RE: Amended Site Plan for Sir John's Plaza Added Parking  
Premises – Tax Lots 122.12-4-56 and 122.12-4-53

This letter accompanies the submission of an amended Site Plan for changes to the site plan approved by the Town of North Castle Planning Board February 10, 2020 for additional parking involving Tax Lots 122.12-4-52 and 122.12-4-53 located at 909 and 913 N Broadway, North White Plains, New York. The amended plan proposes the following changes:

**COMMERCIAL PARKING**  
**SIR JOHN'S PLAZA**  
 NORTH BROADWAY  
 LOCATED IN THE  
 TOWN OF NORTH CASTLE  
 WESTCHESTER COUNTY, NEW YORK.

**PROPOSED CONDITIONS**

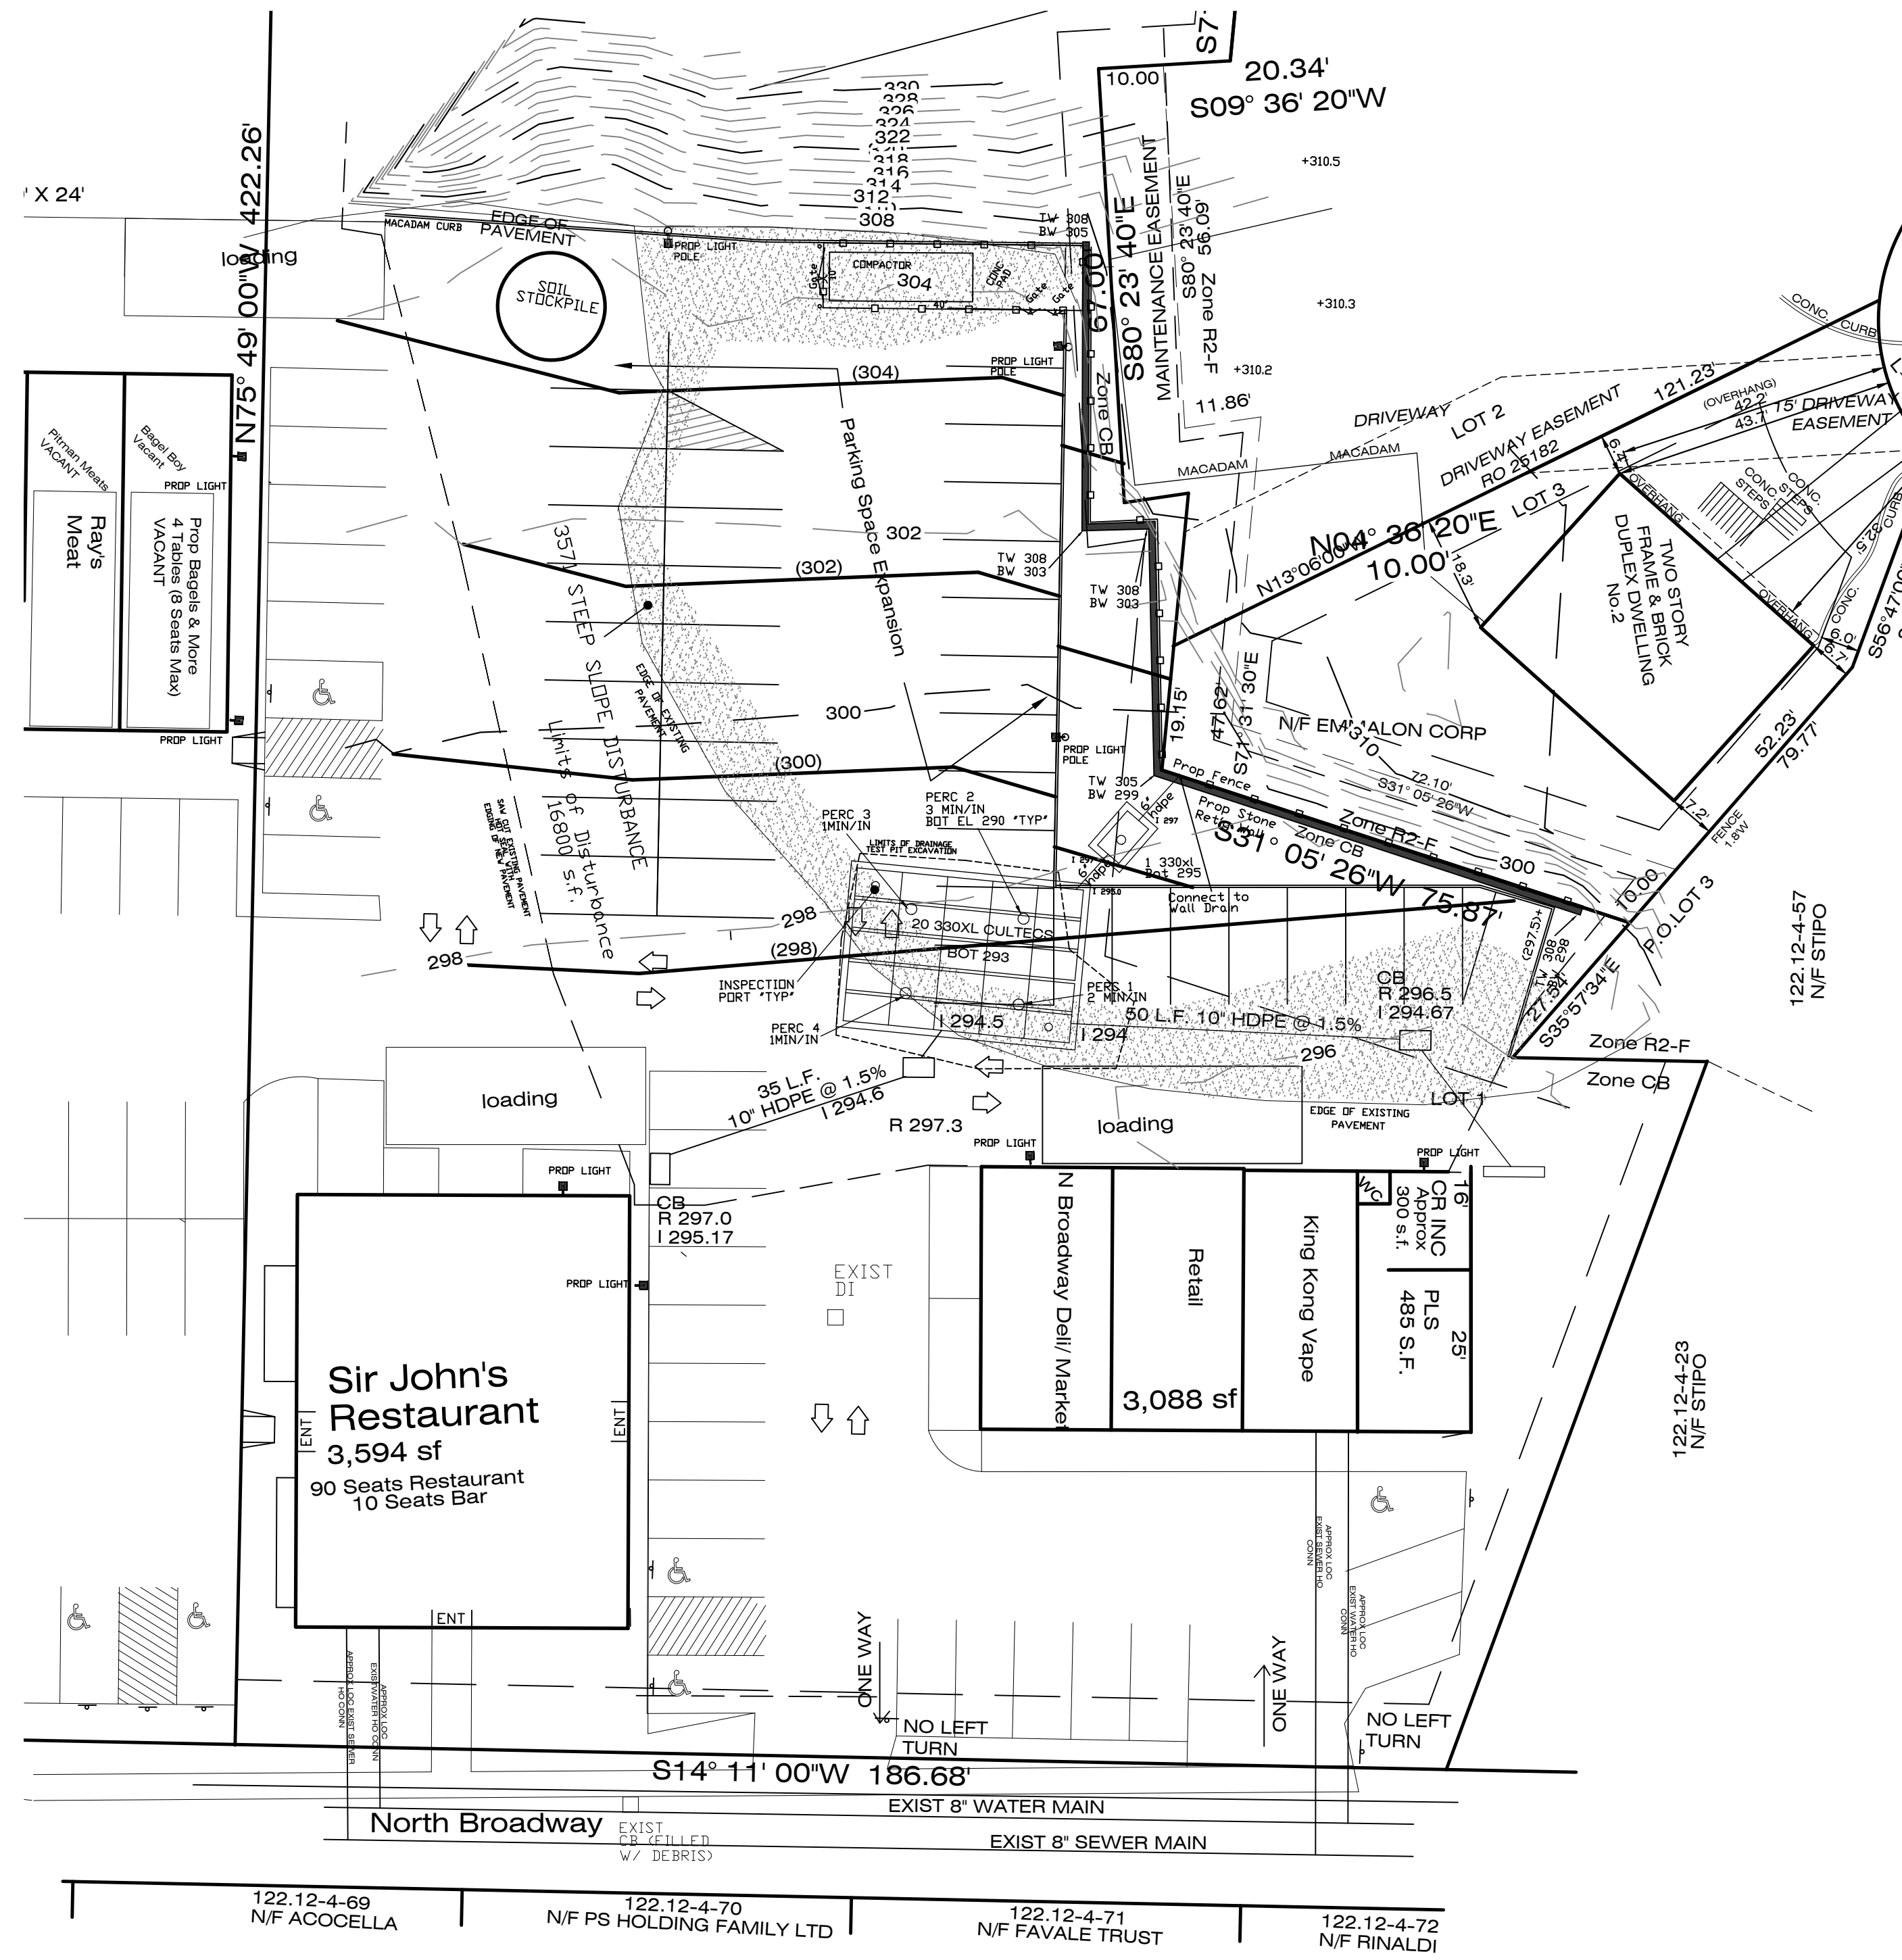
1. Change the location of the wall at the rear of the property to reduce slope disturbance and rock removal. The height of the wall will also be reduced to make the wall more aesthetically appealing.
2. Redesign of the drainage system and reduction in size. Excavation pits for testing demonstrated sufficient percolation rates to support the redesign. This also will result in a decrease in impervious surfaces.
3. Reduction in the total number of parking spaces due to changes to the proposed tenancies in the original approved plan. The proposed parking is still sufficient for projected lease agreements.
4. Repositioning of the trash compacter/recycling area and addition of a second gate to improve access for removal.
